Email to NPSP re. The Parade Masterplan, phase 3 2 August 2018

Figure 4.3: Typical bicycle/car parking lanes layout (parallel parking)

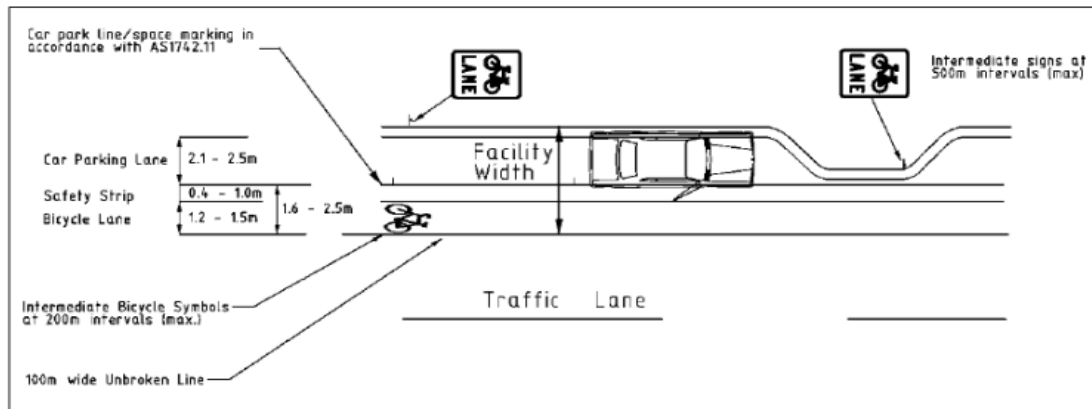
With a suitable 0.4m safety strip between a 1.2m bike lane and 2.1m parking, the bicycle parking lane has a 1.6m **absolute minimum** width, compared to the 1.5m shown. So we'd like to see at least this width achieved, e.g. through a slight reduction in the parking/footpath width.

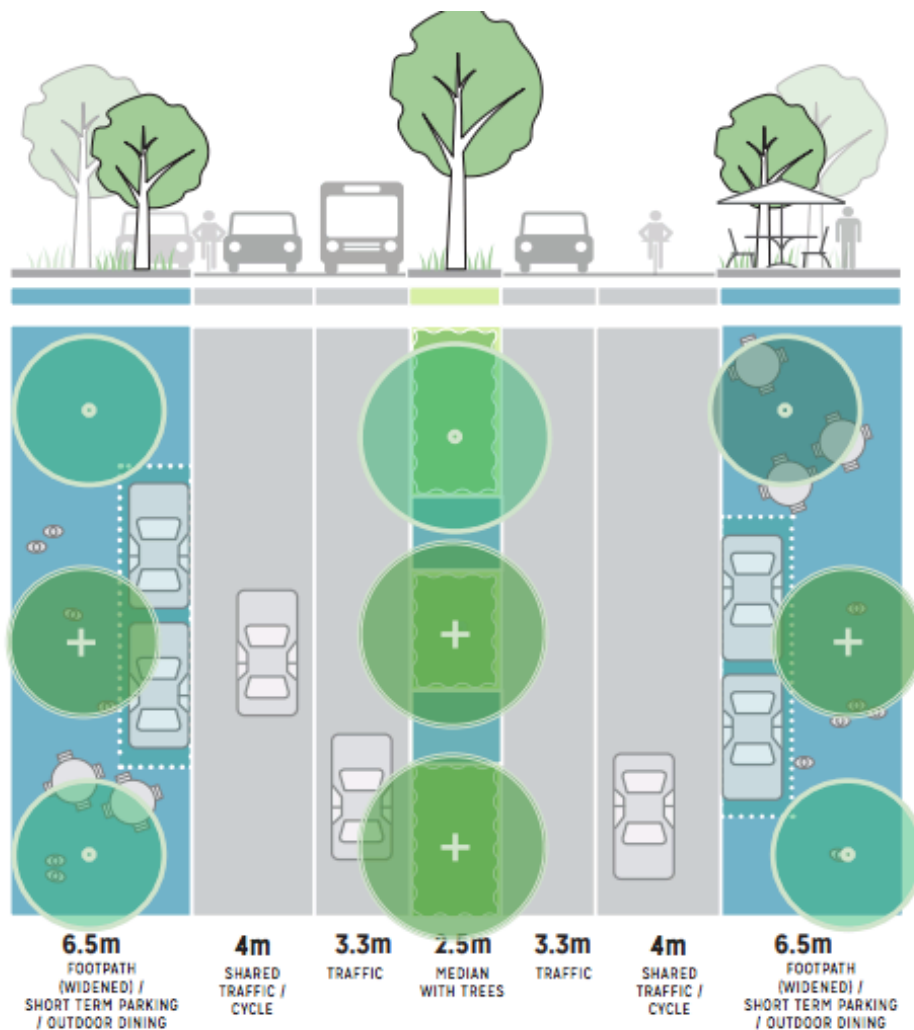
But the real questions are about car parking: its width and how provided. If provided on-street, it could be down to 2.1m when adjacent to a bike lane. But if provided at footpath level you'd probably want 2.5m+ so people getting out of cars have somewhere to stand. I assume it's meant to be on the footpath as the square shape is hell to keep clean otherwise (as with other vehicles, street sweepers have a turning circle and can't get into square corners). We'd propose a hybrid alternative, as seen in Elizabeth St, North Hobart (below).

The parking is separated from the roadway with a spoon drain and detailed with pavers, but slopes upwards to meet the footpath. This enables it to be provided at 2.1m wide without creating a trip hazard. It's semi-indented and square-ish as the corners being at footpath height means you can clean with a green machine. Street furniture, outdoor dining and kerb ramps are effectively as per a normal footpath set-up.

A technical detail is to ensure that the trees are located so their trunks don't get in the way of vehicle doors, for the good of both car users and trees.

Figure 1. Example of a continuous footpath treatment layout.

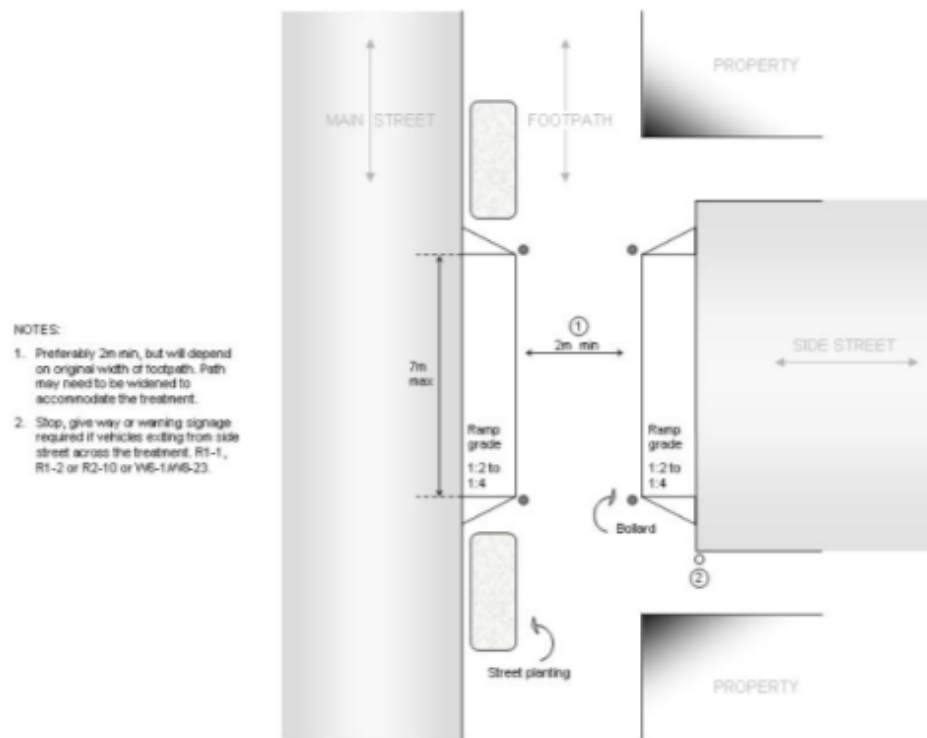
Note the similarity with the Dutch examples. And, of course (with my emphasis added), the text of the RMS guide says:

One other detail of relevance is that the edge of the ramp from the side street lines up with the building line. This creates a tactile edge to guide people with vision impairment across the treated side street, in the absence of a building line – though on this basis, I think the bollard should be located just around the corner from the ramp edge, which would also stop the ramp wing from being a pedestrian trip hazard.
